## Request for Information No. 1

**Project: Layne Park Improvements, 120 N Huntington Street,  
Project No. 7616, Plan No. P-737**

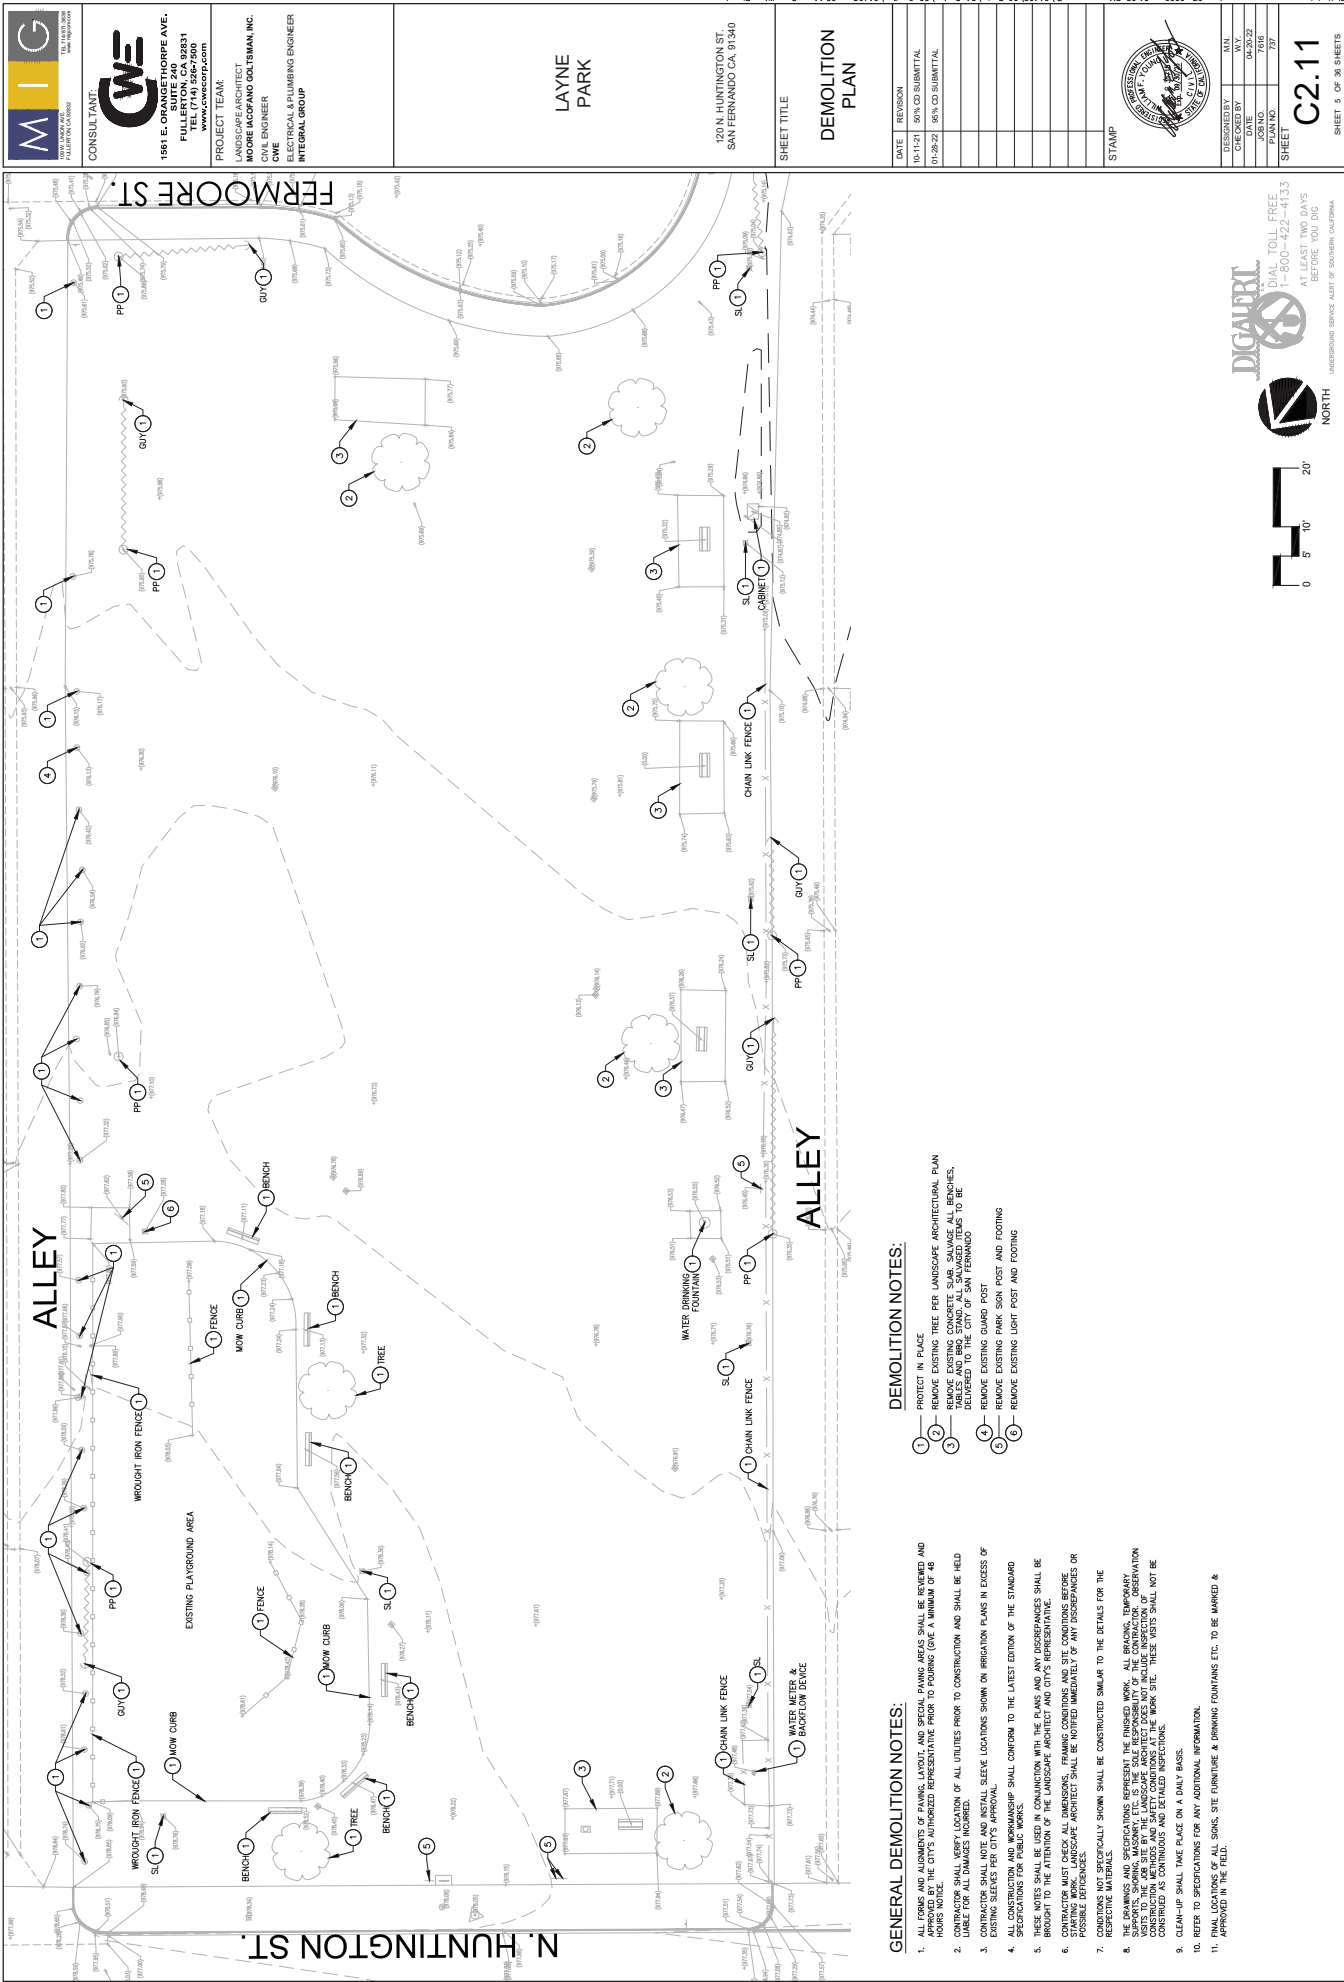
20. Plan Sheet C2.11A Add Alt Demolition Plan - Bottom left of the drawings shows a Circled 11 with an arrow. Under Demolition Notes, I do not see a number 11.

*A: The call out note #11 on Sheet C2.11A Add Alt Demolition Plan should be deleted. Because on sheet C2.12A Alternative Grading Plan has note #21 RELOCATE WATER METER AND REDUCED PRESSURE BACKFLOW DEVICE (LOCATION TO BE DETERMINE BY THE CITY). Please see Attachments "B" and "C" included with this addendum for clarification.*
